Before the Hearings Commissioners at Christchurch City Council

in the matter of: an application by Ryman Healthcare Limited for resource consent to establish and operate a comprehensive care retirement village at 100-104 Park Terrace and 20 Dorset Street, and 78 Park Terrace, Christchurch

Summary of evidence of **Pierre John Malan** on behalf of
Ryman Healthcare Limited

Dated: 25 January 2021

Figure 1 – Section at 15 Salisbury Street (from WAM)

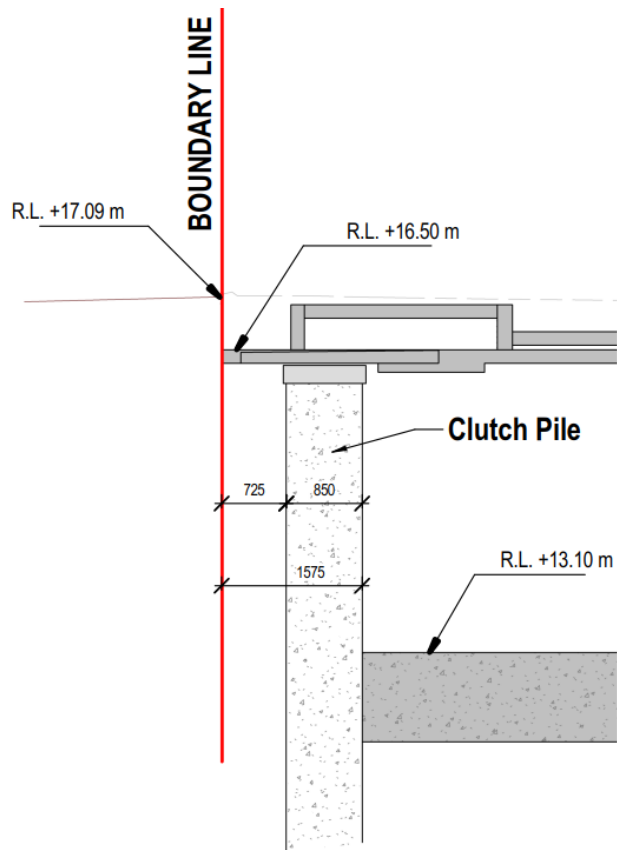
- 16 Mr Aramowicz (paragraph 26) states that drawing S01.A0-040 shows the basement to be 0.6 m from the northern boundary of 15 Salisbury Street. He infers that setback based on the distance to the indicative wall thickness shown by the drawing. He concludes that there is insufficient space to install temporary retention between the basement wall and the site boundary.

- 17 For clarity, I note that the retention system comprises both the temporary and permanent solution, and will be installed inside the wall thickness shown on the drawing. Figure 1 below shows typical offsets of the clutch tubes from the boundary at 15 Salisbury Street.

- 18 The retention system is expected to comprise an 813 mm diameter steel tube (shown on the Figure as 850 mm, and the thickest part of the retaining wall). This will be embedded within a pre-drilled, concrete filled hole approximately 960 mm diameter. The piles will be spaced 300 mm apart along the wall (i.e. at 1113 mm centres, with the clutches fully covering the 300 mm gap between tubes). The steel tube wall thickness will be around 10 mm.

- 19 The typical setbacks to the 15 Salisbury Street boundary are therefore approximately:

- 1575 mm to the internal basement face (and the basis for my statements in evidence and reports)
- 725 mm to the likely closest approach of the steel tube to the boundary.
- 1150 mm to the centreline of the piles (and the closest approach of the excavation to the boundary)
